**Project: IEEE P802.15 Working Group for Wireless Personal Area Networks (WPANs)**

**Submission Title:** [DS-UWB Responses to TG3aVoter NO Comments]

**Abstract:** [Response to NO voter comments and feedback regarding the DS-UWB (Merger #2) Proposal]

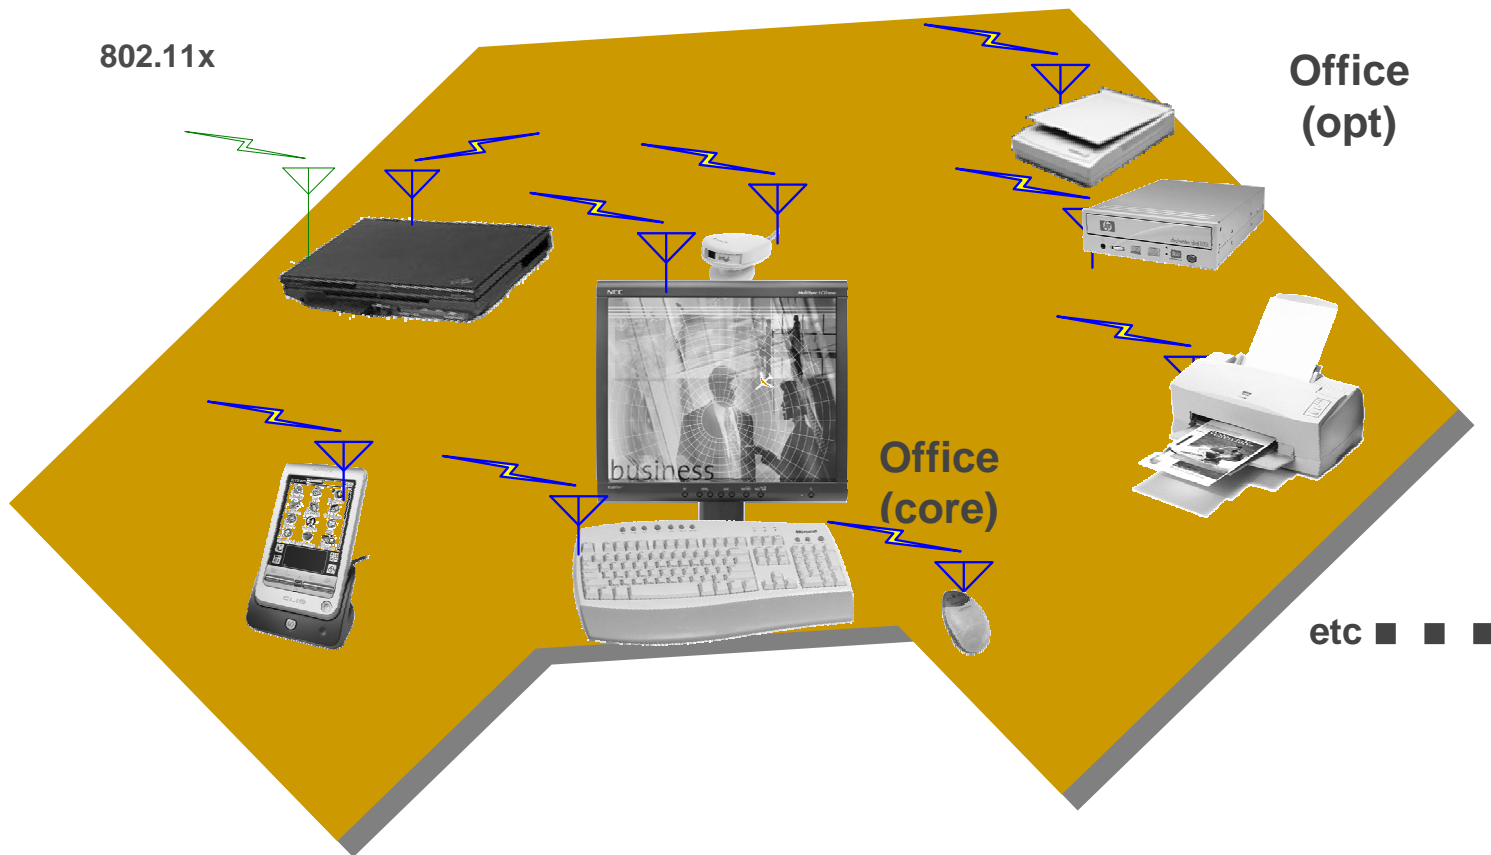
- Comments:
  - “Video links, the primary potential application for link speeds greater than 1Gb are very sensitive to data loss. Claims of high throughput achieved by obscuring the reliability problem are extremely flawed. The willingness of this proposer to put the customer at risk in this manner is highly disturbing. I wish to see the proposer describe their system in terms of usable bandwidth. Below 1Gb, applications can frequently tolerate higher packet error rates stated in the evaluation criteria. Above 1Gb, applications shift to video and need measurements in terms of a 1% packet error rate. To state a 15% rate is absurd and must be stopped.”

- My skepticism about the practicality of the unprotected 1Gbps data rate has been confirmed by recently published simulation results e.g. in 802.15-04-0483r5. For example, CM1 range for low band 1000Mbps on slide 24. Even in the case of no interferers, the packet error rate could not be shown to drop below 39% at any distance. Therefore, the authors have a way to go before they have convincingly shown a path to robust transfer of Gigabytes of information in a real world environment. If this system is to rely on ARQ as has been suggested, then the total system throughput has to be demonstrated in the context of the 15.3MAC MIFS and SIFS times, the bandwidth allocated to ARQ retries, the impact of multiple piconet interference, etc. If such an overall system analysis for Gbps data rates were presented in a convincing way, I would consider changing my no vote to a yes.

- Assertions of commenters:
  - Uncompressed video links require lower PER than other forms of data
  - High rate video or other applications should not be addressed in TG3a

- We do not agree with these assertions
- Packet losses typically leads to retransmission, not to data loss
- UWB applications requiring 1 Gbps identified in multiple documents

- DS-UWB has multiple modes (with FEC) supporting 1+ Gbps (2 bands)
- Simulations in different AWGN and multipath channel conditions
- This is the only proposal considered by TG3a that has demonstrated the capability to satisfy this 1 Gbps requirement from the SG3a CFAs & TG3a Requirements Document
  - No MIMO or higher order modulation (e.g. 16-QAM) is required

# 90% Outage Comparison High Rates

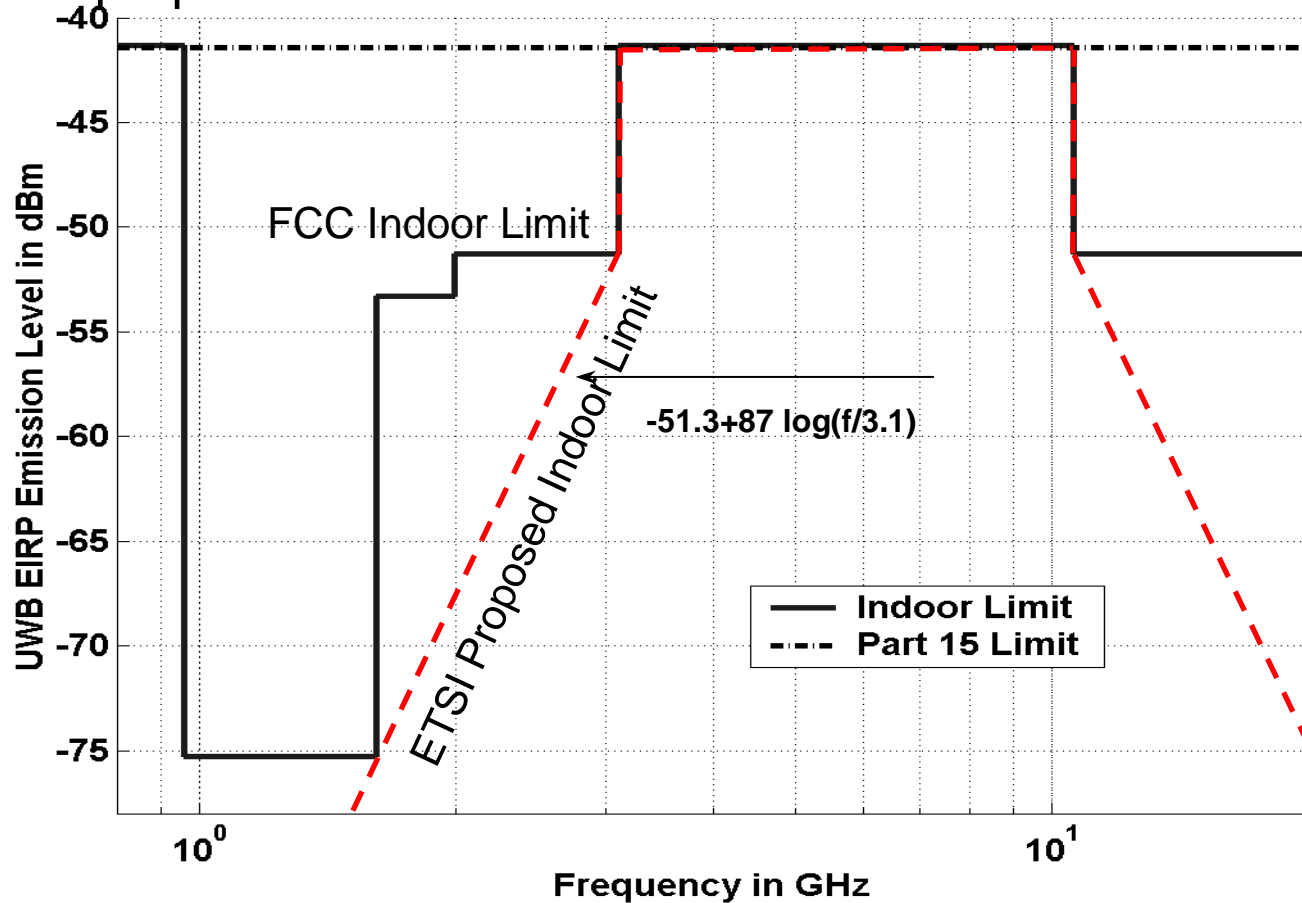
- A comparison of MB-OFDM and DS-UWB at higher data-rates has not been consistent with the information presented by DS-UWB for the 90% outage range (at 500 Mbps, 3.0 m for CM1 and 1.9 m for CM2 in DS-UWB, while at 480 Mbps, 2.9 m for CM1 and 2.6 m for CM2 in MB-OFDM). I hereby question if the DS-UWB comments such as: DS-UWB takes full advantage of UWB propagation, and DS-UWB performance excels as speed goes up. Performance difference is natural consequence of channel physics. If as given in the DS-UWB proposal, have any technical ground. A convincing explanation is required before ever reconsidering my NO vote.

Channel Model	DS-UWB 500Mbps	MBOFDM 480Mbps	DS-UWB advantage	DS-UWB 660Mbps	MBOFDM 480Mbps	DS-UWB advantage
CM1	4.6	3.2	44%	4.2	3.2	31%
CM2	3.7	3	23%	3.2	3	23%

Theoretical Root-Raised Cosine pulse shape showing OOB roll-off

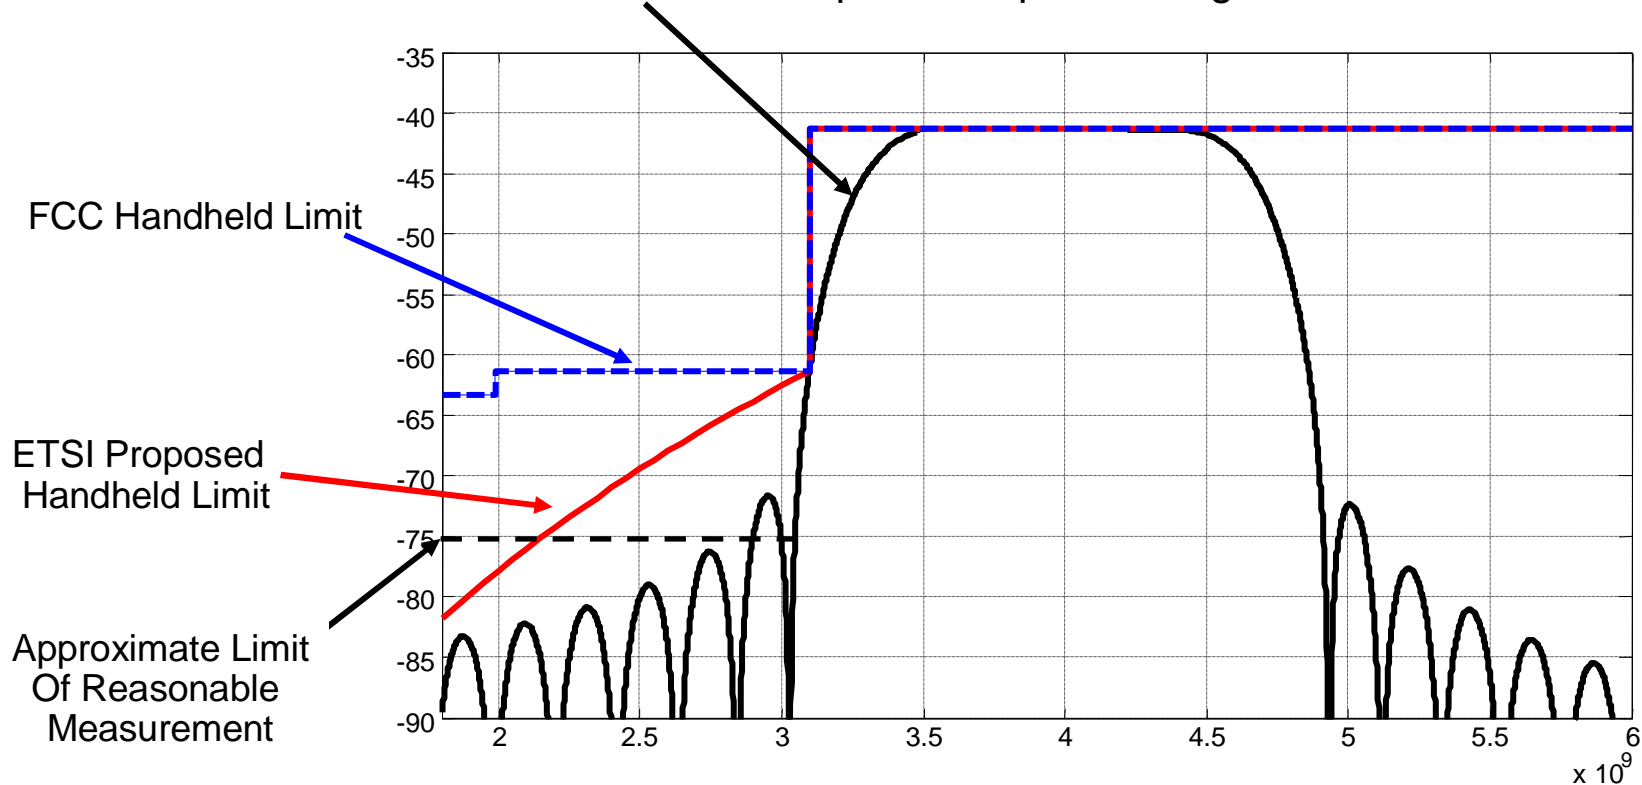
- I would like you to quantify the impact on the DS-UWB system of having to meet strict out of band emissions requirements for services such as IMT-2000 etc. corresponding to proposed protection levels being discussed in ITU-R, etc.

- Lack of an effective mechanism to solve out-of-band and in-band interference for incumbent and future radio service operators is a serious disadvantage with the DS-UWB technology. MBOA has proposed MB-OFDM as a solution to meet both performance and interference mitigation; at present, it is the only one UWB technology that provides a mechanism to coexist with other radio services. As being discussed at ITU-R, CEPT and other regulatory meetings, UWB interference is a global issue, and industry needs a standard solution that meets both performance and interference mitigation. Techniques proposed from DS-UWB in the past either accompany an excessive performance drop or lack technical feasibility. Without an effective technical remedy for DS-UWB, it is extremely difficult to reconsider my NO vote.

- Natural pulse shape of RRC rolls-off quickly outside operating band
- Further control of emissions for co-located applications is possible

# OOB Emissions: Measurements of MB-OFDM

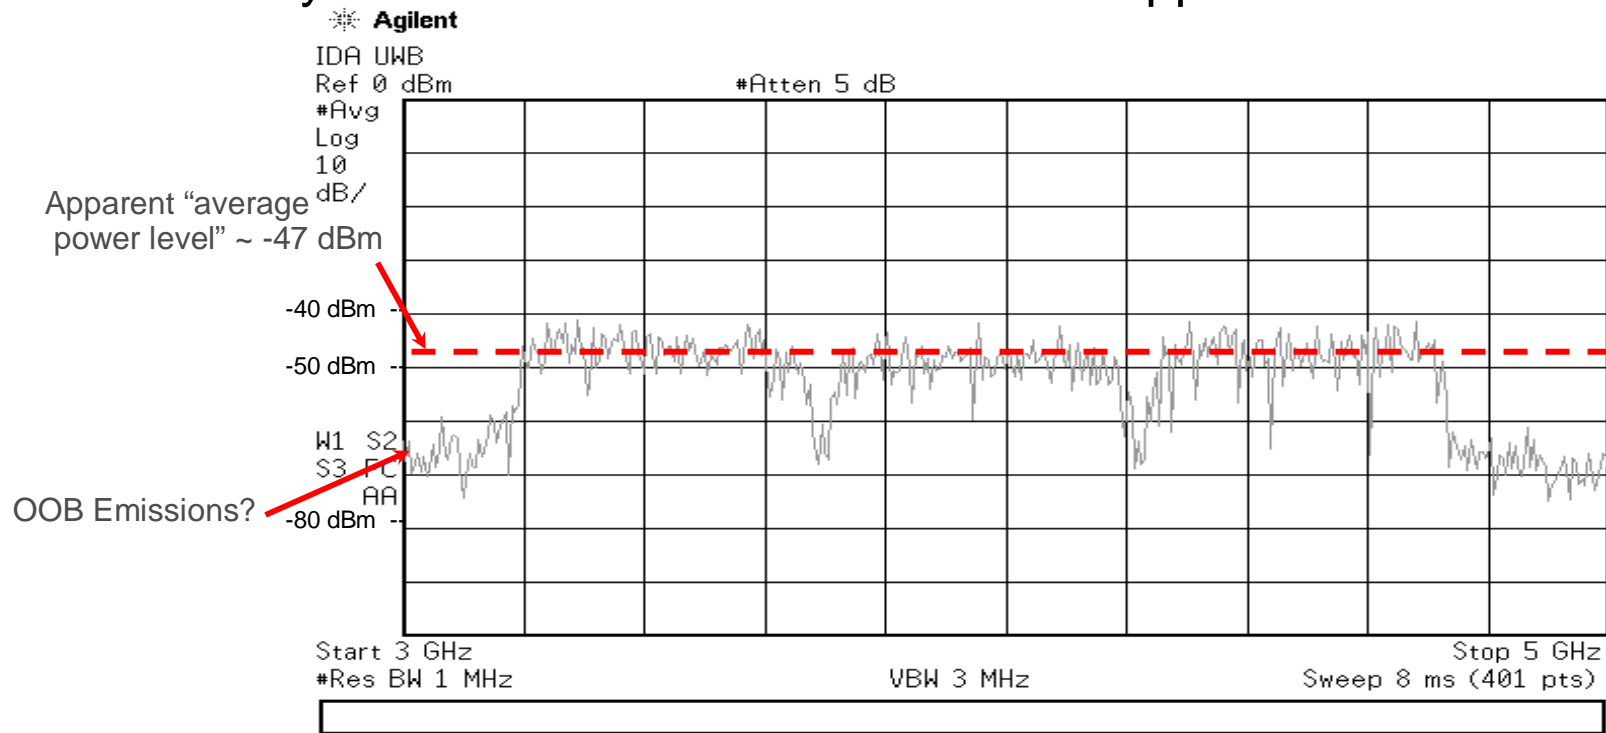
- Commenter indicates that only MB-OFDM can meet OOB emission levels required to coexist with other systems
- Publicly released measurements do not support this conclusion

# Simple Example of Pulse Shaped to Create a Notch

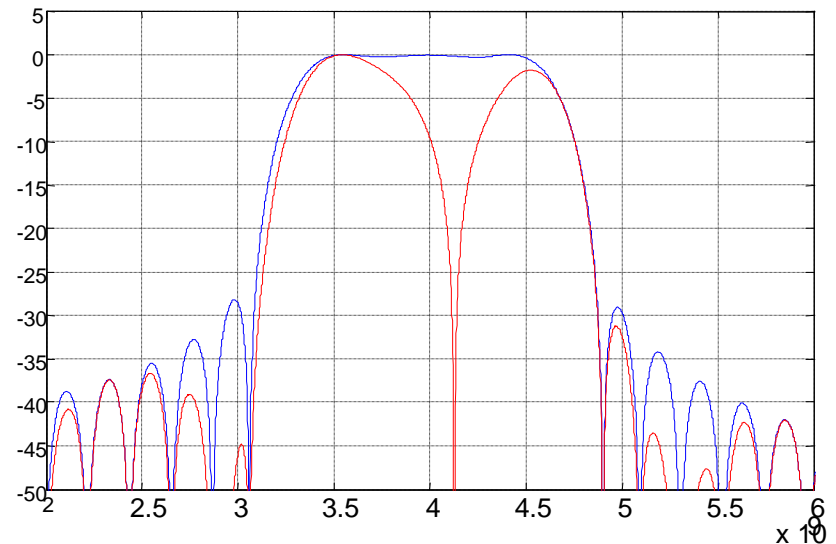
- Comments
  - Any attempt to change the spectrum will generate ISI which will make the equalizer problem even worse
  - Spectral shaping of DSSS introduces ICI and rapidly degrades performance
  - This pulse shaping will also severely degrade the performance
- Response:
  - Pulse shaping lengthens the pulse only marginally
  - A well-designed receiver is already designed to tolerate channel dispersion of 50+ ns and is relatively insensitive to pulse shape – the notch looks like part of the channel
  - Conclusion: Pulse shaping does not cause unmanageable ICI or ISI

- Pulse shaping lengthens the pulse only marginally
- A well-designed receiver is already designed to tolerate channel dispersion of 50+ ns and is relatively insensitive to pulse shape – the notch looks like part of the multipath channel
- Conclusion: Pulse shaping does not cause unmanageable ISI

# ADC Complexity

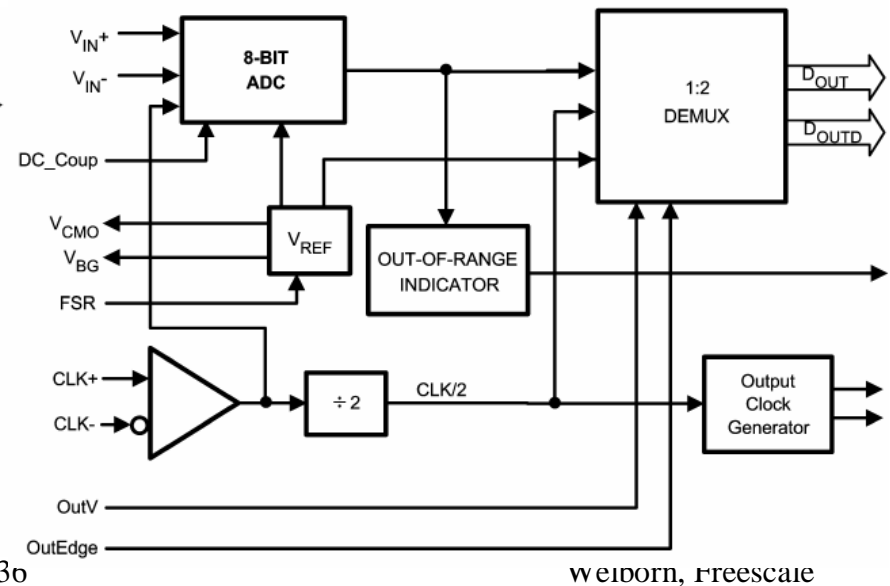
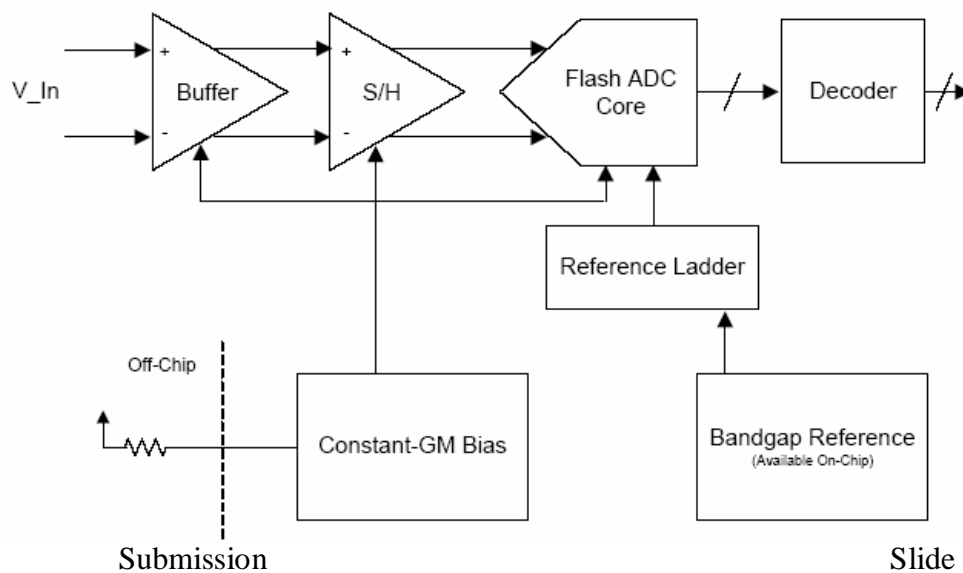
- Comment:
  - The ADC speed and amplifier quality seem to dictate implementation in an exotic process, which in my humble opinion would place a significant damper on adoption. Selecting a standard with significant adoption hurdles will encourage fragmentation of the medium, as lower-cost, higher performance technologies pass by the standard.
- Resolution:
  - ADCs at speeds and quality requires for DS-UWB are already available in commercial products

# ADC in 0.13 CMOS ~ 50mw 3-bits 2.5 Gsps

## Snowbush Microelectronics ADC8005

- 6-bits - ENOB: 5.2 bits at Nyquist
- DNL at +/- 0.5 LSB, INL at +/- 1.0 LSB
- Input dynamic range: +/-0.4V differential
- Analog bandwidth: 5GHz
- Single 1.2V power supply
- Power dissipation: 500mW
- Input capacitance: 150fF single-ended
- Sophisticated digital error correction
- Designed in a 0.13um TSMC CMOS process

- ## National Semi ADC081000
- 8-Bit, 1 GSPS A/D .18 CMOS
  - ENOB @ 500 MHz Input 7.5 Bits (typ)
  - Operating 1.45 W (typ)
  - Scale to 3-bits ~ 45mw
  - Power Down Mode 9 mW (typ)
  - Single +1.9V ±0.1V Operation
  - Guaranteed No Missing Codes
  - DNL ±0.25 LSB (typ)

# DS and MB-OFDM Filters Remove OOB Interference

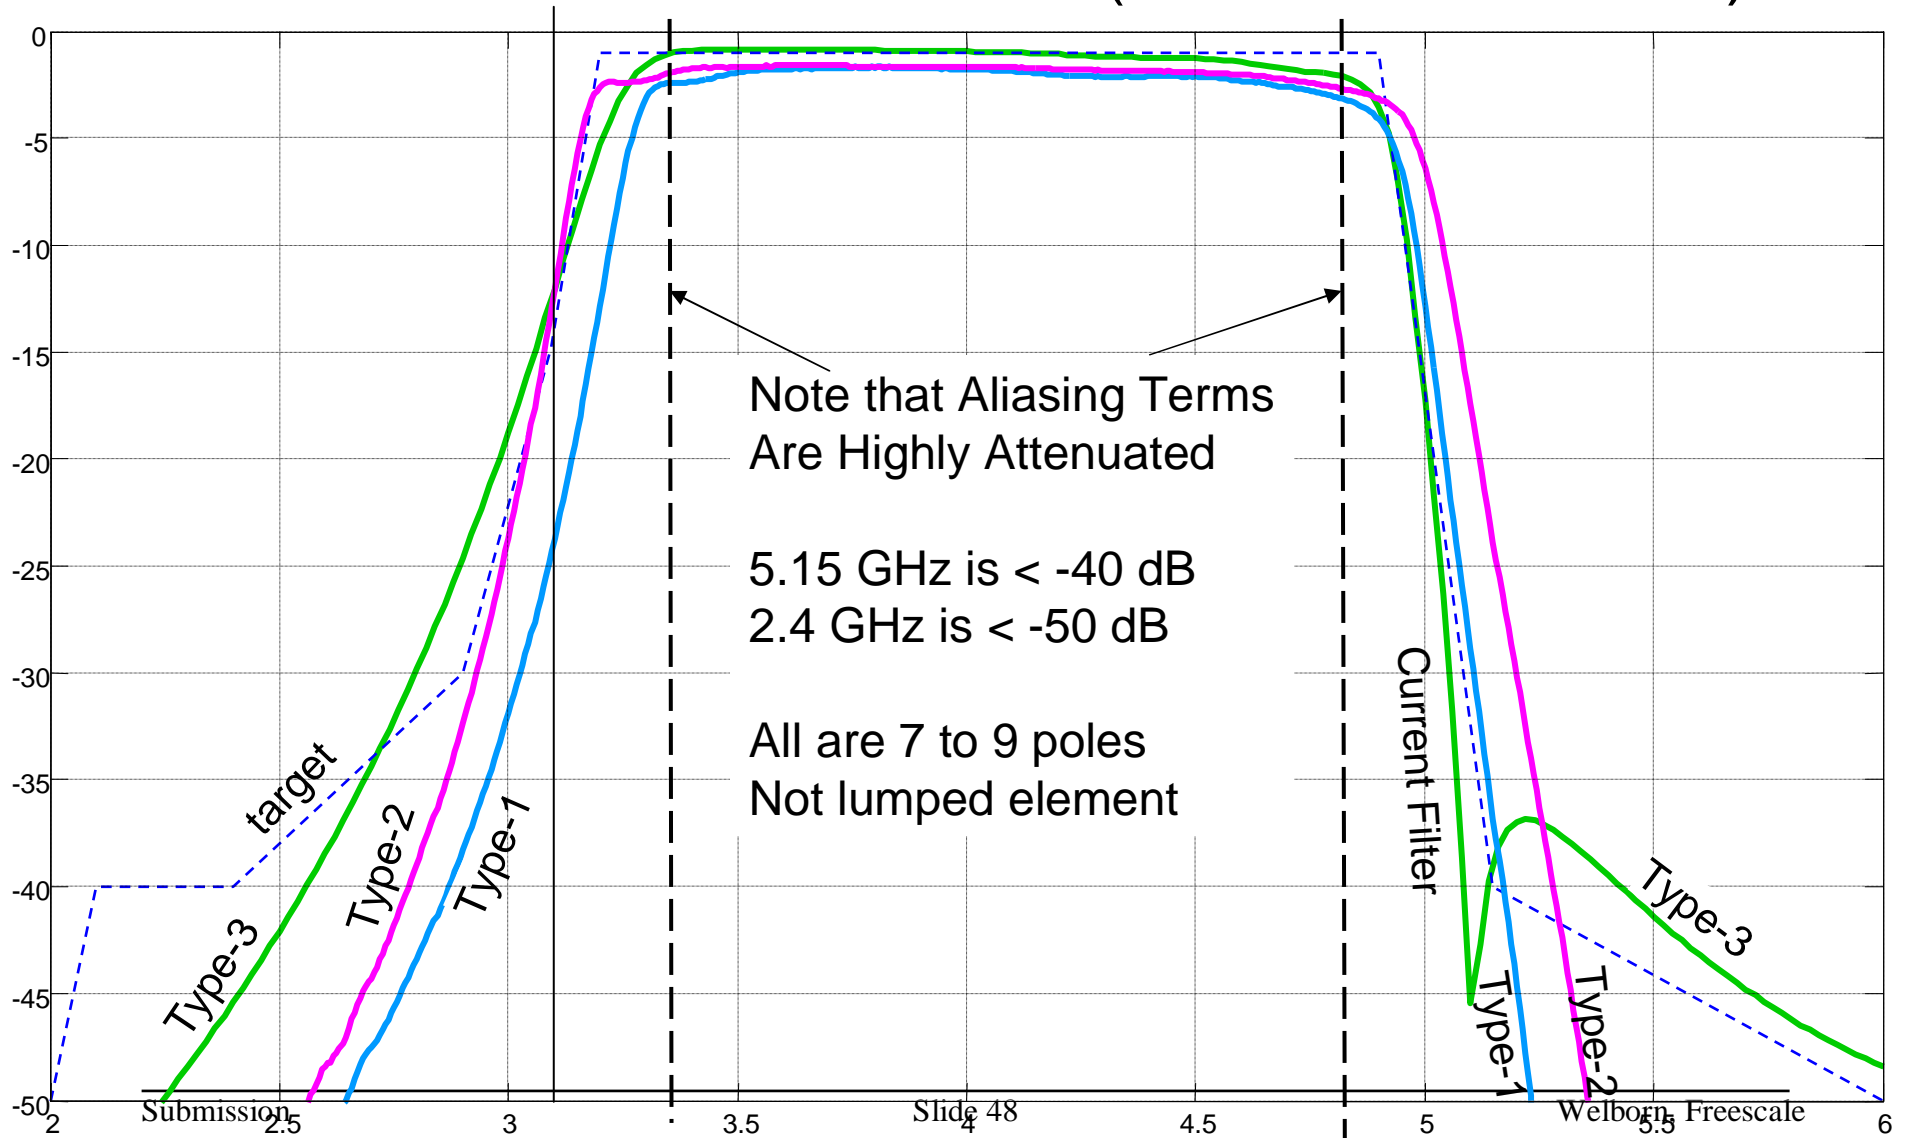
- Also, since there is no over-sampling proposed, it is easy for strong OOB signals to aliased into the 1.3 GHz wide passband. The degree of analog filtering necessary to protect such a system from alias bands has not been discussed. I would consider changing my no-vote to a yes, if the authors of merged proposal #2 could show their analysis of the order of filters required at baseband and at RF to achieve a 1m separation requirement from other unlicensed services in the UNII and ISM bands. Once the required filter orders have been established, we need to be convinced that such filters can be built on-chip with the required intrinsic bandwidth (1.3 GHz).

- In the case were analog correlators are not used, the need for explicit baseband channel-select filters is paramount. In previous/existing highly analog implementations of DS-UWB, it may have been that analog correlators provided some intrinsic selectivity of their own, prior to the ADC. This benefit will be removed once a DSP based approach with chip-rate sampling is introduced. The product implications of these wide-band, high dynamic range filtering requirements need to be carefully considered. I guess this is one of the down-sides of proposing a solution “based on true Ultra-Wideband principles” as claimed by the authors of 140r10.

- I would consider changing my no vote to a yes, if it could be shown that the required on-chip filtering can be integrated with low die area in a mass-market, low cost, process.”

- OOB energy must be removed so LNA is linear for all radio types
- Once the LNA is linear, SNR is key
- Pros and Cons of On-chip versus Off-chip RF filtering is a design choice that has similar trade-offs for either proposal
- Manufacturers are free to choose based on the target market requirements
